# Groundwater Transfer Review Summary Form

Transfer/PA # T- 14260

Applicant Name: T and K Sester Family LLC

**Application T-14260, T and K Sester Family LLC  
T1S, R4E, Sections 16 and 21**

**Theis Drawdown Analysis – Authorized From-POA MULT 2531 to CLAC 57578**

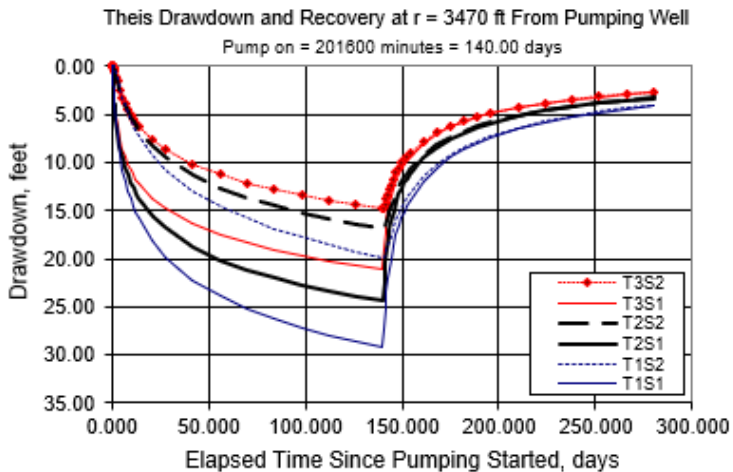
☐ Yes   ☒ No   If yes, explain: To evaluate the potential additional interference with CLAC 57578, a Theis (1935) drawdown analysis was completed. Aquifer parameters used for the analysis were derived from regional data and studies (Pumping Test Reports; McFarland and Morgan, 1996; Swanson et al., 1993).

To provide a conservative analysis, it was assumed that authorized From-POA MULT 2531 would be pumped non-stop at the maximum authorized rate under both certificates (0.46 cfs, ~207 gpm) up to the associated duty, which would be reached within approximately 140 days of pumping. Pumping at proposed To-APOA MULT 67819 was also simulated at 0.46 cfs (~207 gpm).

Results of the Theis comparative analysis indicate that interference with CLAC 57578 could range from about 10 to 30 feet based on these conservative pumping scenarios. Using the 2024 static water level measurement reported for CLAC 57578 of approximately 245 ft bls, there is approximately 250 feet of available drawdown in CLAC 57578. This amount should support both the current authorized use of CLAC 57578 (i.e., its current drawdown or pumping water level) and the range of interference drawdown predicted for this proposed use; thus, it is not likely that the proposed use will result in CLAC 57578 or another similar groundwater right from receiving the water to which it is legally entitled.
